Tracer AVi

ESD Grounding Update

Product: Tracer AVi

Issue: Display is unresponsive and requires a power cycle to restore operation

Figure 2. RD-2 Back

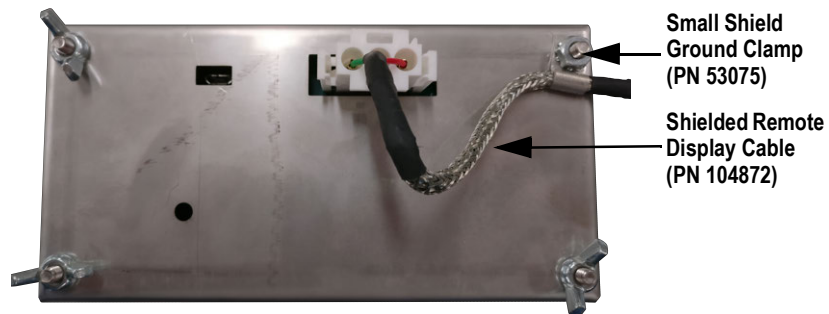
6. Ground the opposite end of the shielded remote display cable (PN 104872) to the back of the RD-2 using a small shield ground clamp (PN 53075) and one of the existing backplate nuts. The clamp must be fully contacting the exposed shielding of the cable.
